Trudeau Building Rehabilitation

Addendum #2: Historic Saranac Lake – Trudeau Building Rehabilitation
PROJECT LOCATION: Reconstruction at 118 Main Street, Saranac Lake, NY 12983
Issue Date: February 5th, 2023

Please be advised of the changes noted below to the Bidding documents and responses/answers to requests for information and questions received to date during the bidding period.

1 PLUMBING CELLAR PLAN
 P1.0 SCALE: 1/4" = 1'-0"

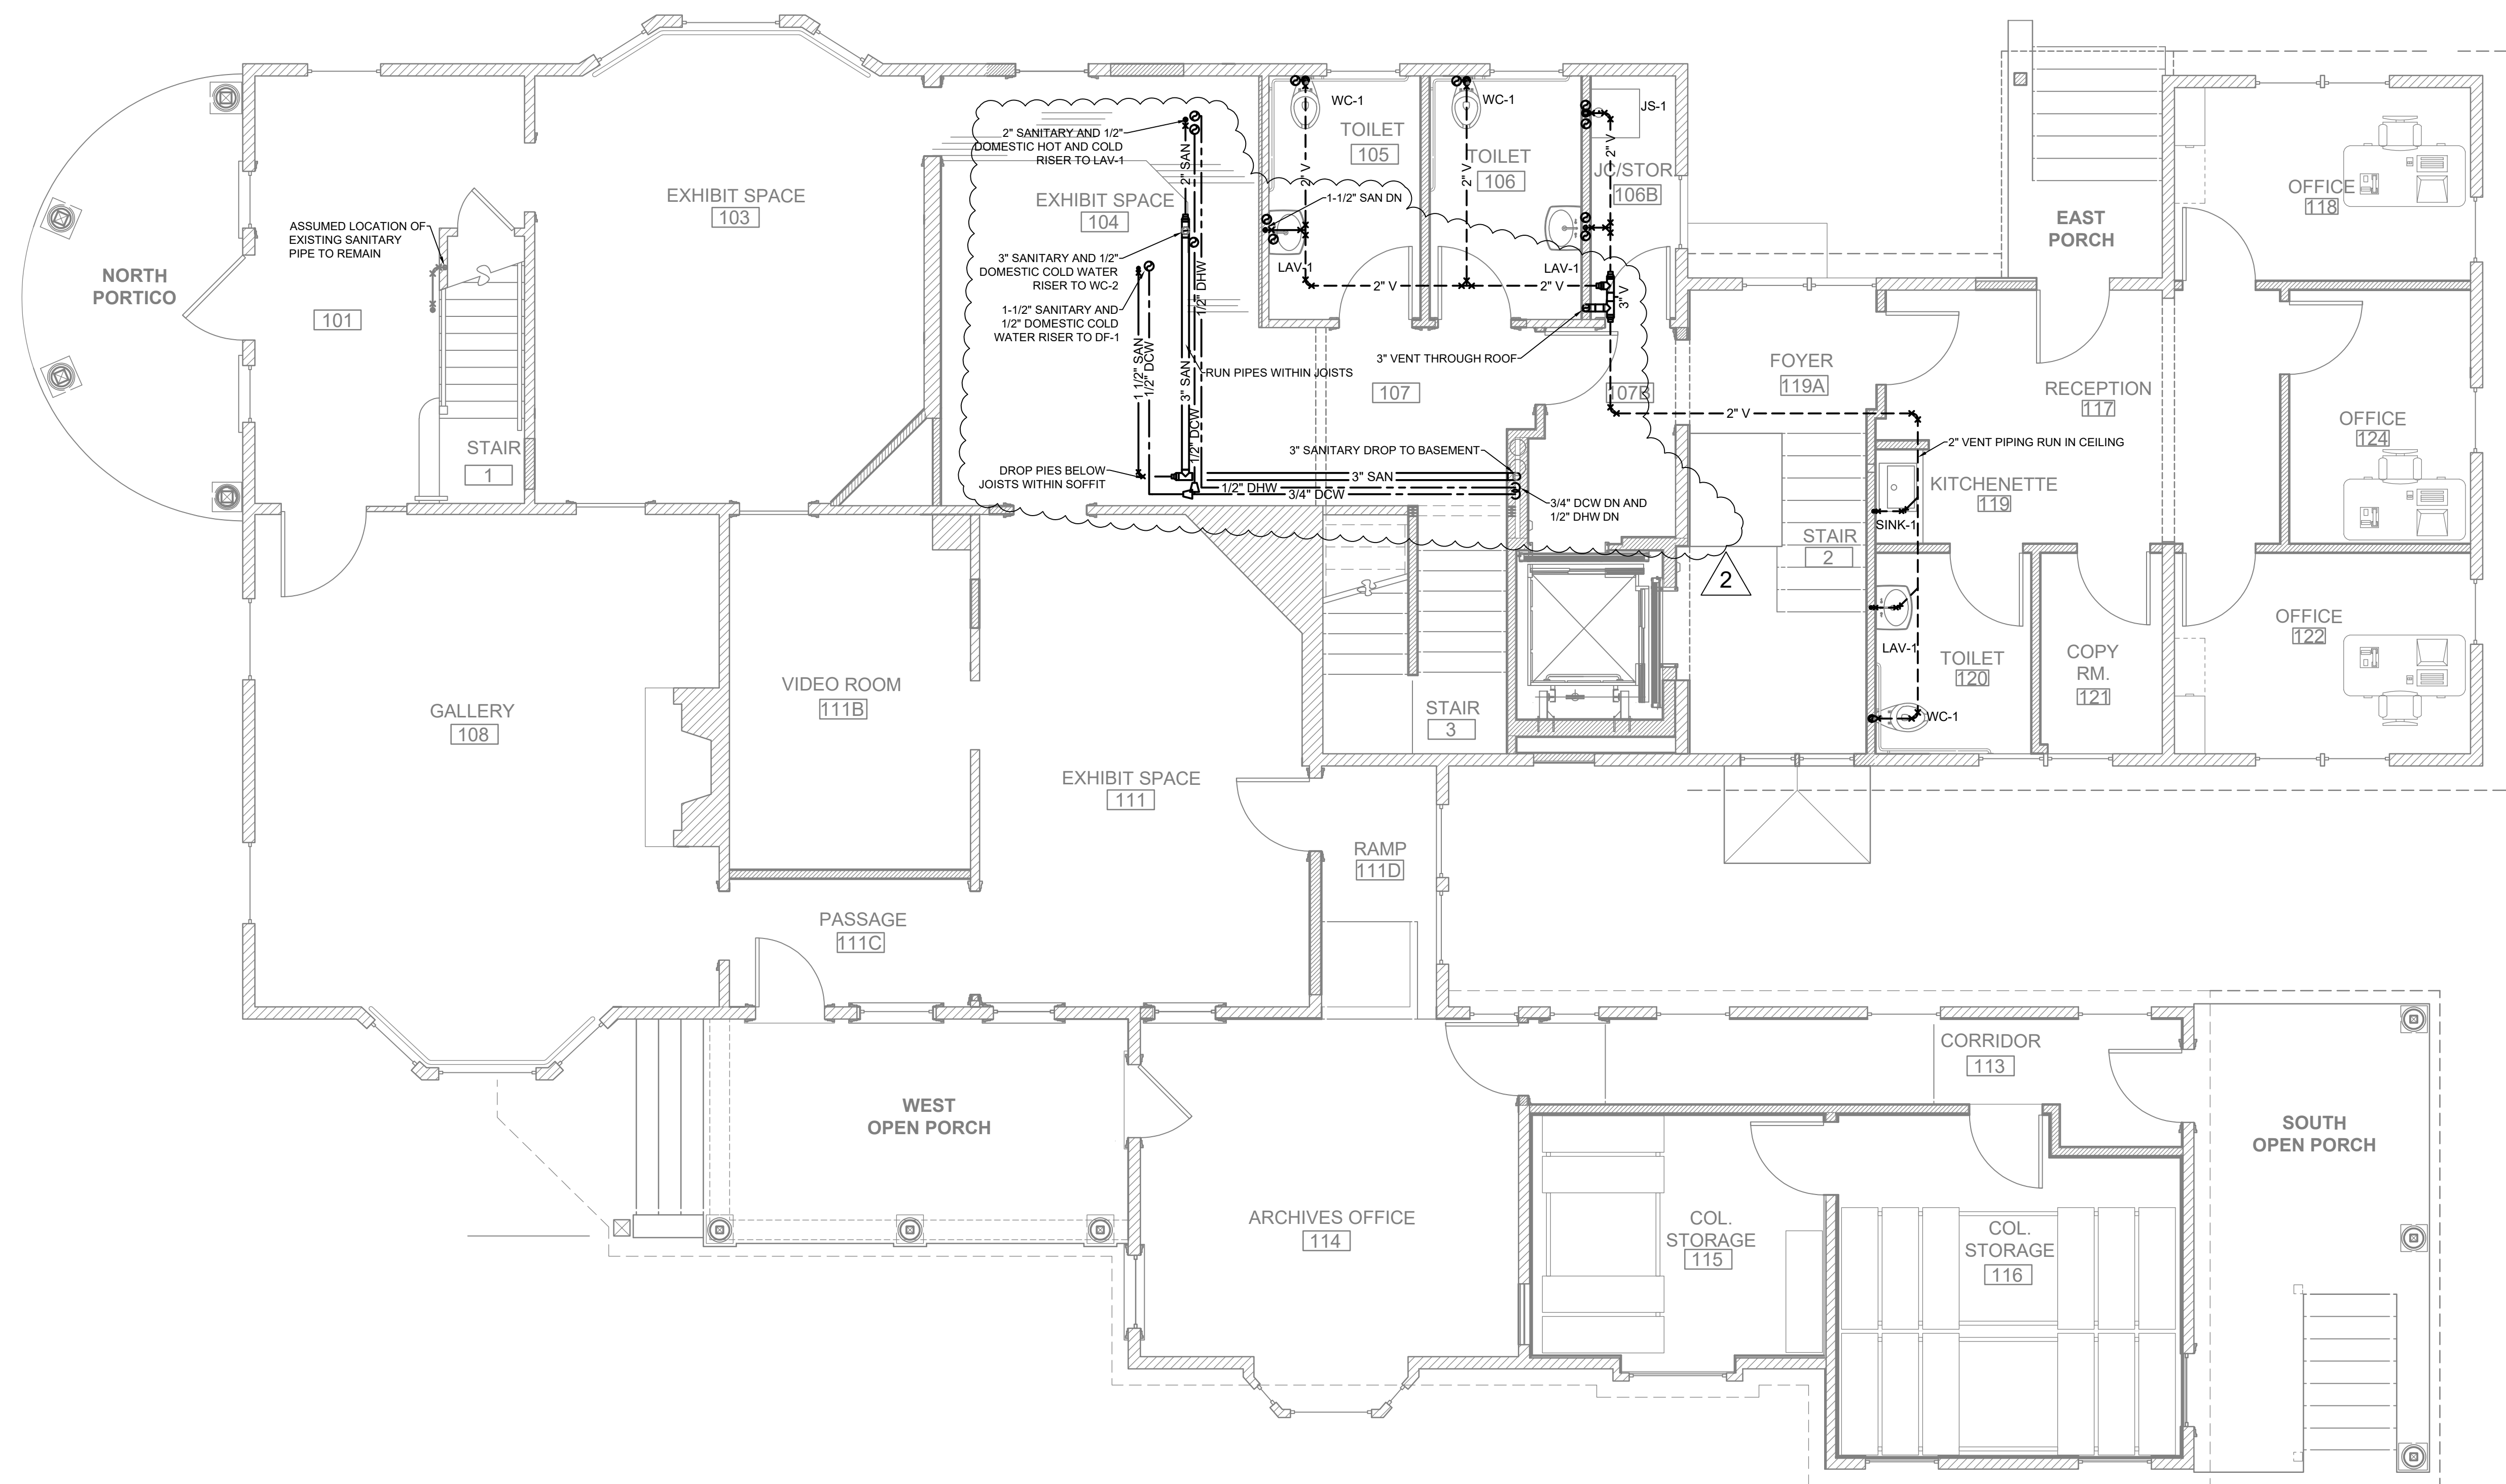
1. Adjusted the new work drawing to account for modified piping of the second-floor bathrooms.

1 PLUMBING FIRST FLOOR PLAN
 P1.1 SCALE: 1/4" = 1'-0"

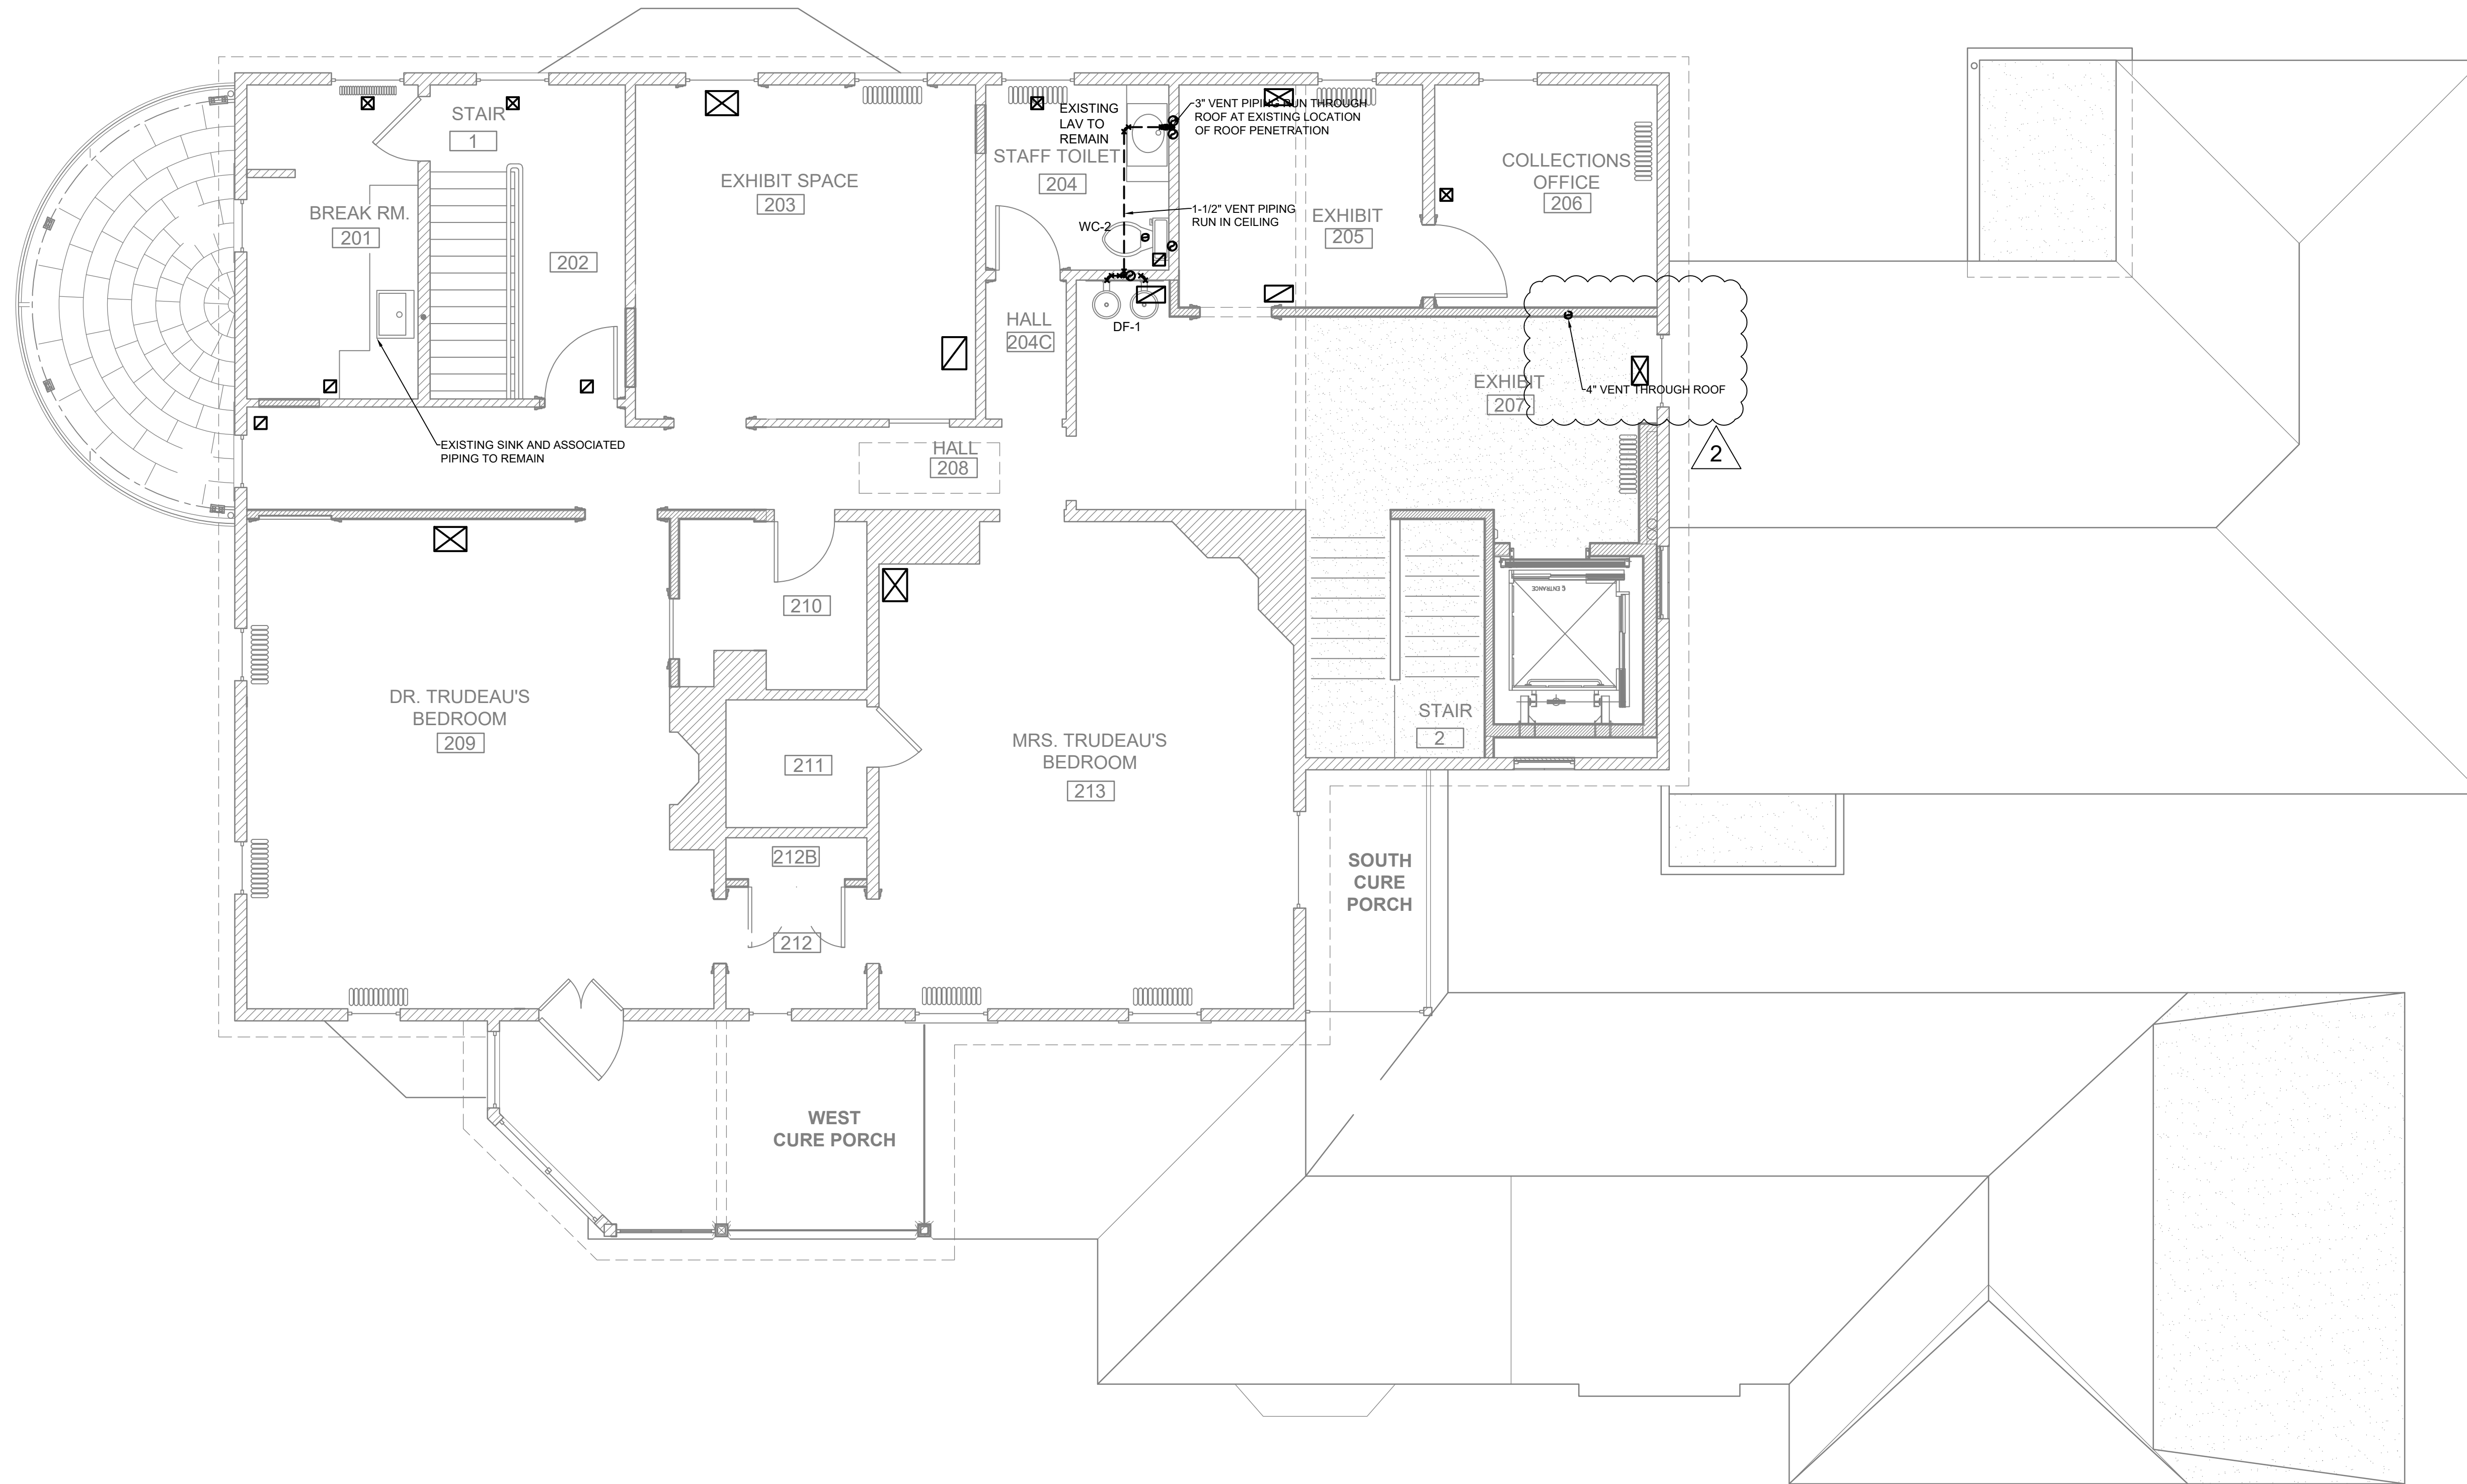
1. Adjusted the new work drawing to account for modified piping of the second-floor bathrooms.
